Kiwi Property No.2 Holdings Limited Response to Comments in relation to Drury Metropolitan Centre Consolidated Stages 1 and 2 under Fast-track Approvals Act 2024.

APPENDIX A: KIWI PROPERTY HOLDINGS NO.2 LIMITED RESPONSE TO PARTIES INVITED TO COMMENTS ON DRURY METROPOLITAN CENTRE CONSOLIDATED STAGES 1 AND 2

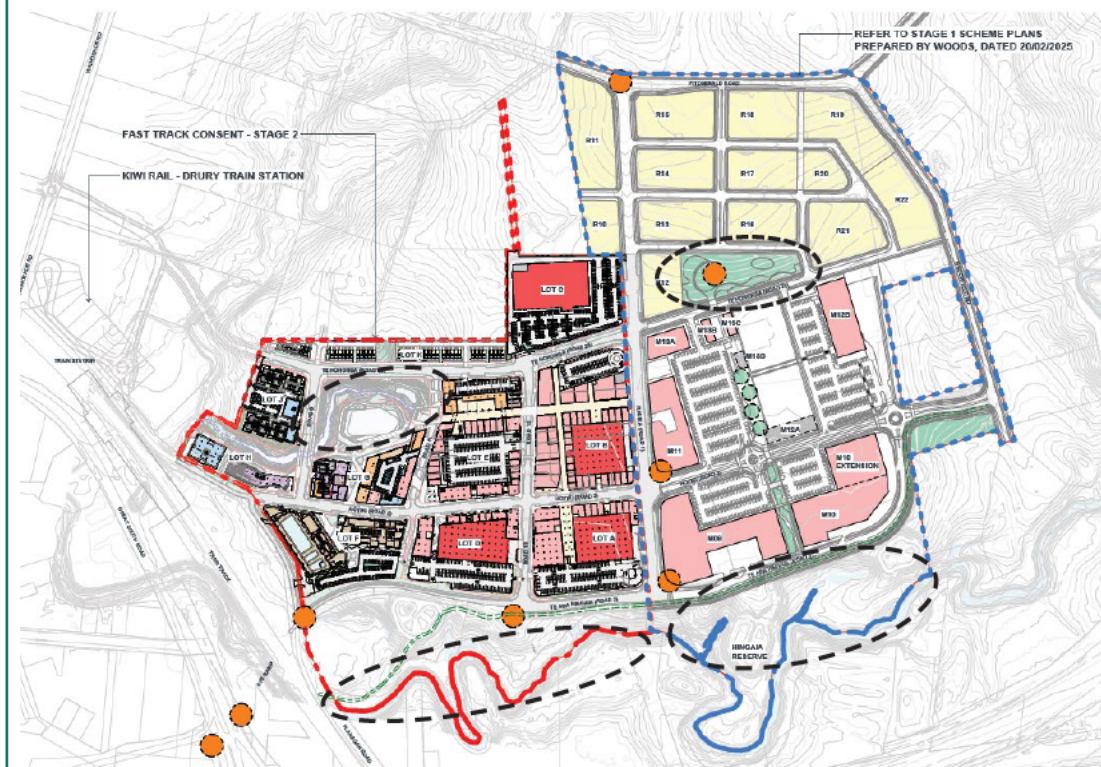
Summary of Comment (Papakura Local Board)	Applicant Response
The comments from the Papakura Local Board generally relate to the provision of open space, active mode connections within the Project and connections with the broader area, stormwater treatment and piping of Stream A.	<p>We respond relative to those topics below:</p> <p><u>Provision of Open Space</u></p> <p>The Project includes the provision of open space in the form of Valley Park and extension of the 20m wide esplanade reserve along the Hingaia Stream as shown on the Landscape Design Report provided with the application. Those landscape plans show Valley Park will feature a series of informal pedestrian paths and boardwalks through riparian planting to support amenity, recreation and activity around the central stormwater basin and along the stream. The area of Valley Park is approximately 2.2ha which incorporates the riparian margins of Stream A and is significantly larger than the indicative neighbourhood park (as expressed through Auckland Council’s Open Space Provision Policy) as shown on Precinct Plan 2. It is therefore considered that the Project does provide open spaces and opportunities for recreation.</p> <p>We also consider that it is relevant and appropriate to look at the extent of public open spaces provided in the Drury Centre Precinct more broadly. The figure below shows the Stage 1 and 2 fast-track areas and the open spaces provided are circled in black dashed lines. When considered holistically for Drury Centre as a whole and particularly across these two large projects being delivered by Kiwi Property, it is considered that the provision of open space is appropriate and will provide sufficient opportunities for recreation.</p>

In respect of the tree coverage comments, Boffa Miskell have assessed the proposed planting in the Project against Auckland Council's Urban Ngahere canopy cover targets requirement of 12–30%. A site-wide canopy analysis has been undertaken to assess the Project against the urban ngahere principles and it is identified that the Project currently achieves a 13% canopy coverage using a conservative estimation method.

With further design development in the subsequent detailed design stages there is the potential to reach the 15% minimum target. This is likely to be achieved through greater use of larger "generic" (8m diameter) trees within streetscapes, where medium (5m diameter) trees have been conservatively assumed to date. For a metropolitan centre of this density, the current 13% achieved demonstrates strong responsiveness and intent to meaningfully contribute to canopy cover.
